U.S. Department of Energy
Office of River Protection

04-WTP-268

U.S. DEPARTMENT OF ENERGY (DOE), OFFICE OF RIVER PROTECTION (ORP)
RESPONSES TO THE DEFENSE NUCLEAR FACILITIES SAFETY BOARD (DNFSB)
CONCERNS

Responses to Issues Raised in July 21, 2004 Defense Nuclear Facilities Safety Board (DNFSB) Letter Regarding Waste Treatment and Immobilization Plant (WTP) Ventilation Systems Design

Calc No.: 24590-PTF-S0C-S15T-00005, Rev. 0A

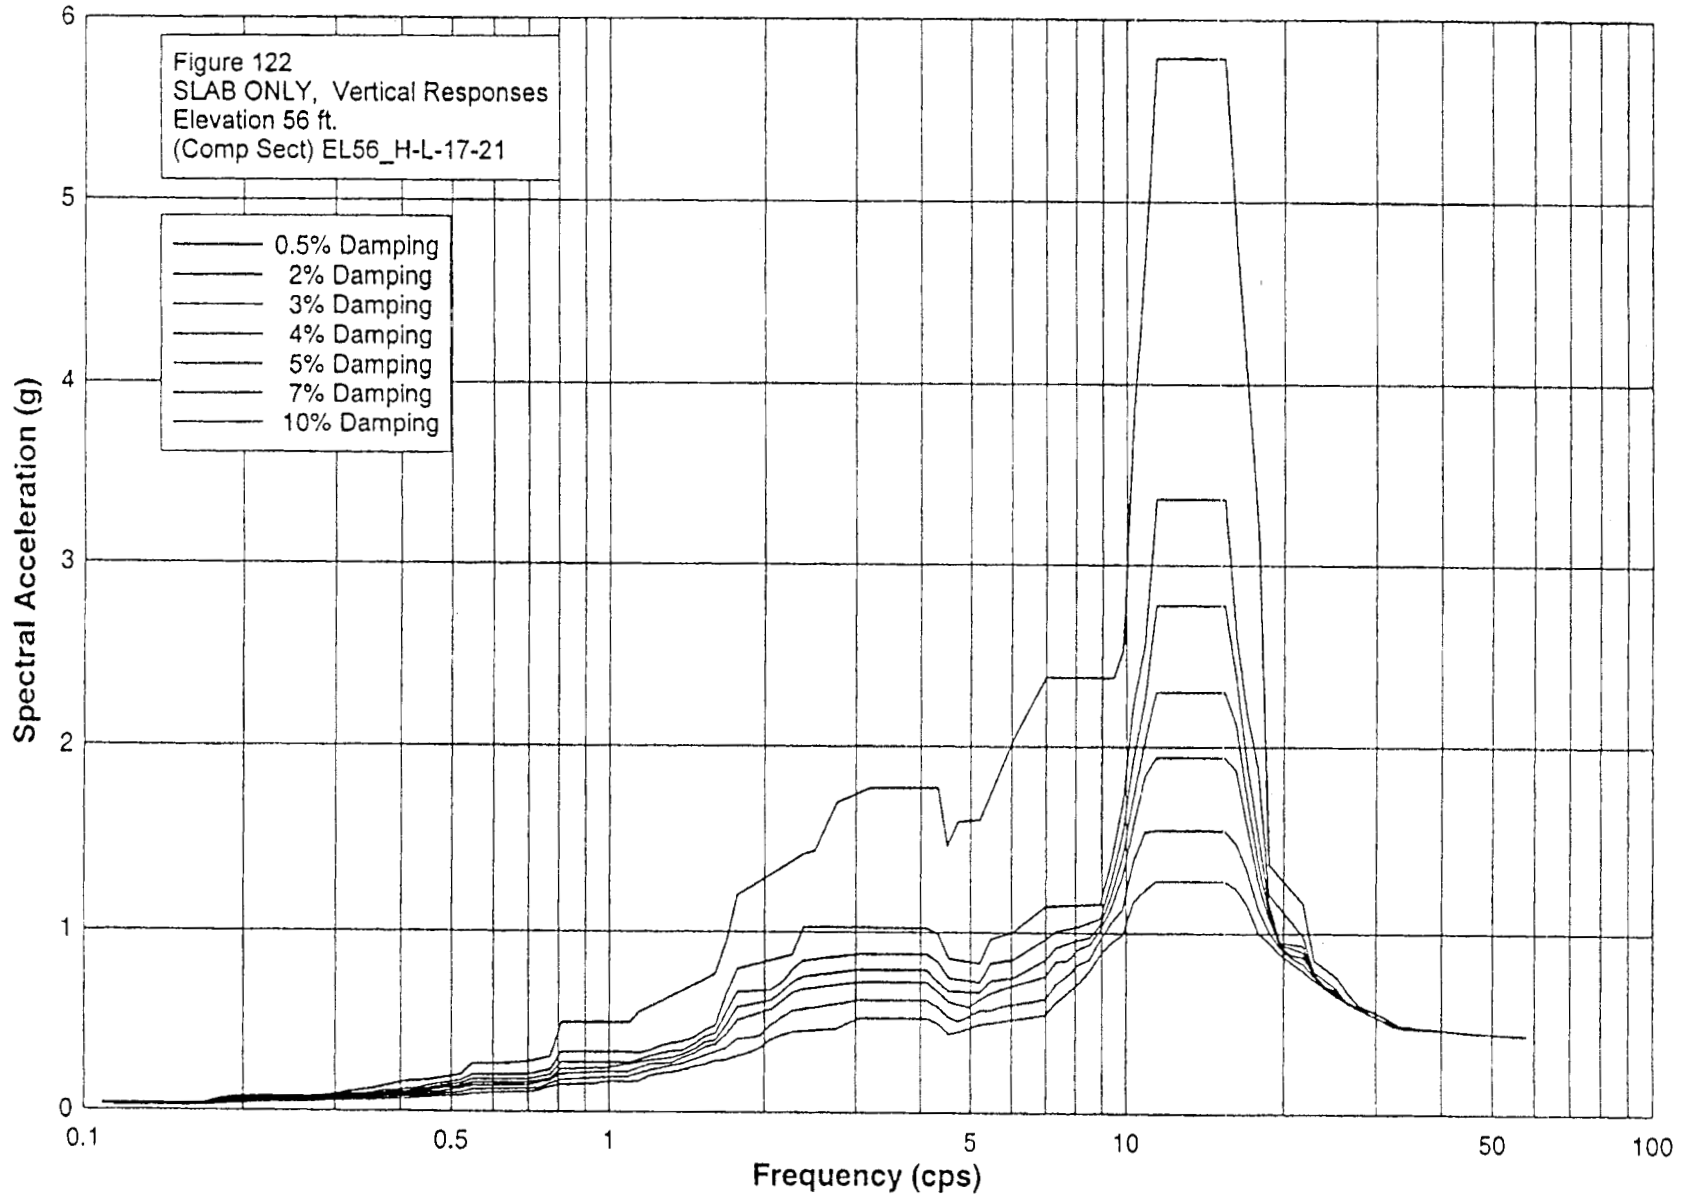
WTP-04-281-02 The planned ventilation filter housing shaker table tests will use a bounding seismic spectra as input for the shaker table tests. The staff wants to review the bounding data for suitability.

Response: The WTP Project will not use bounding data for the PT and HLW facilities. The specific In-Structure Response Spectra (ISRS) curves for each facility will be used and separate testing for each facility will be conducted. The applicable curves, by elevation and column line, for the Remote Change HEPA Filter housings will be used which shows the expected frequencies and accelerations in the north/south, east/west, and vertical directions. The reason for applying the ISRS curves specific to each building and not using bounding data is as follows:

The Remote Change HEPA Filter Housings in the PT and HLW buildings will require separate testing for the following reasons:

- a) The housings are supported by steel platforms. Since the platforms are not rigid, they need to be simulated for testing. The platform configurations are different. Therefore, their simulations would be different, requiring separate testing.
- b) ISRS for PT and HLW buildings are different.
- c) It is likely that the external loads on the housings, e.g., connected ducts, in PT could be different from those in HLW.

Enclosed are the ISRS curves applicable to the Remote Change HEPA Filter housings in the HLW and PTF facilities.†
